Baruch Academic Complex
Baruch College - Site B
New York, NY
Page 14900 - 1

SECTION 14900

VERTICAL RECIPROCATING CONVEYOR

ADDENDUM #1 (CONTRACT #15)

11F PARTITION (2 HR. RATING)

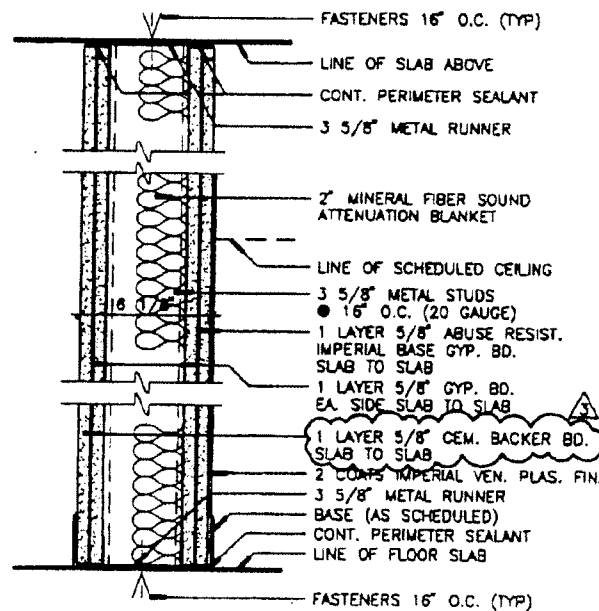
11N SAME AS 11F EXCEPT ADD 3RD LAYER GYP. BD. TO LOBBY SIDE OF WALL TO MAINTAIN 2 HR. RATING WITH REVEALS

11F PARTITION (2 HR. RATING)

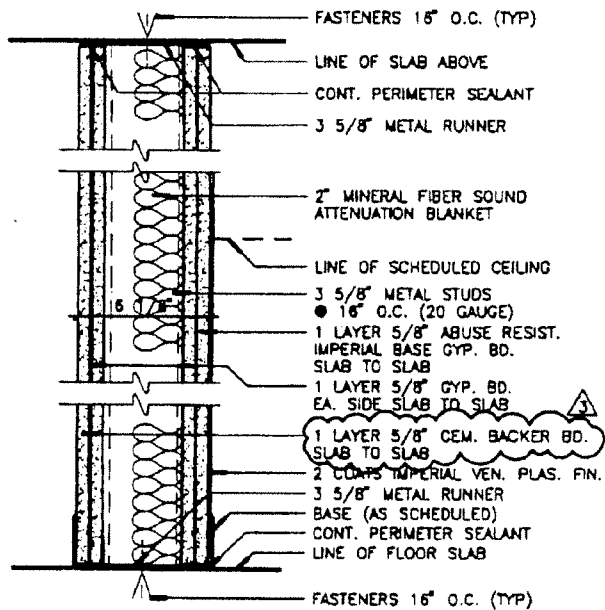
11N SAME AS 11F EXCEPT ADD 3RD LAYER GYP. BD. TO LOBBY
SIDE OF WALL TO MAINTAIN 2 HR. RATING WITH REVEALS

41 PARTITION
3'-11\"/>

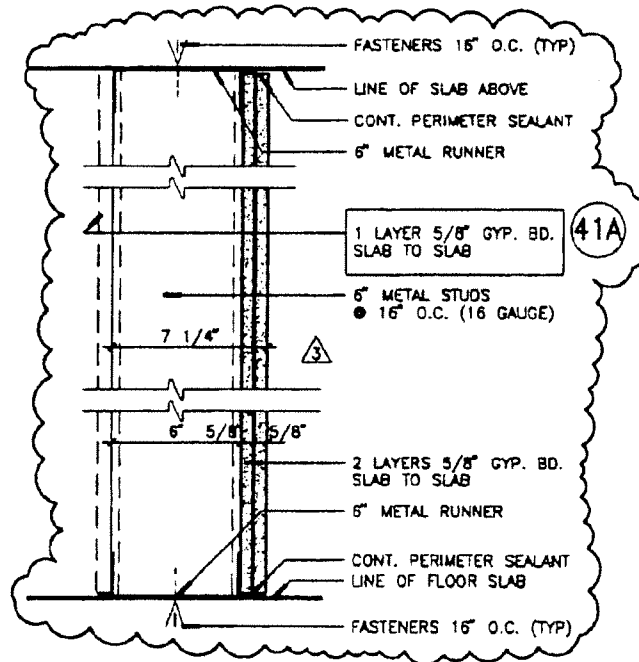
41A— SAME AS 41 EXCEPT WITH
1 LAYER OF GYP. BD. OPP. SIDE
